# UNITED STATES PATENT AND TRADEMARK OFFICE

APPLICATION NO.	FILING DATE	FIRST NAMED INVENTOR	ATTORNEY DOCKET NO.	CONFIRMATION NO.
09/450,054	11/29/1999	ASHOK V. KRISHNAMOORTHY	32	7078

**Office Action Summary**

**DETAILED ACTION*****Claim Rejections - 35 USC § 102***

FIG. 1

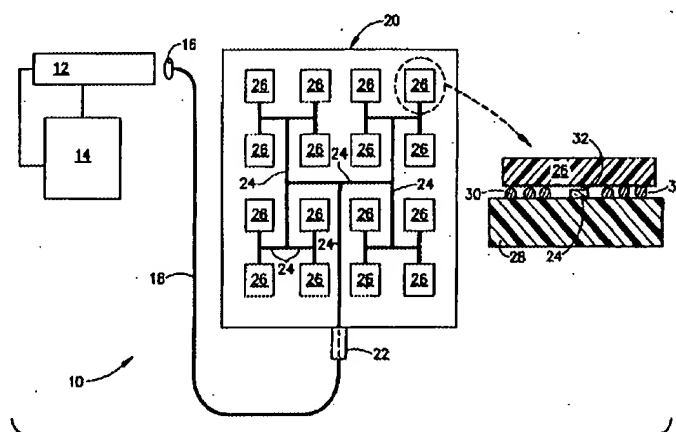
2. Claims 1-2, 4-5 and 10-11 are rejected under 35 U.S.C. 102(b) as being anticipated by Koh et al. (5416861). Koh et al. disclose a network **Fig. 1** for distributing a power signal in an optoelectronic circuit **20** comprising a plurality of electrically conductive pathways forming at least one level, wherein the portions of the conductive pathways are interconnected; a plurality of segments **24** forming each level, wherein each segment of the level is equal in length; means for coupling **16, 18 and 22** the power signal from a primary input to a point at the center of a first level; terminal nodes **26** coupled at the extremities of a last level for supplying the power signal to devices that form at least a portion of the

optoelectronic circuit **20**; and wherein the number of segments connecting the primary input to each of the terminal nodes is equal.

Regarding claims 2, Koh et al. disclose all stated limitations, **see Figs. 1-2.**
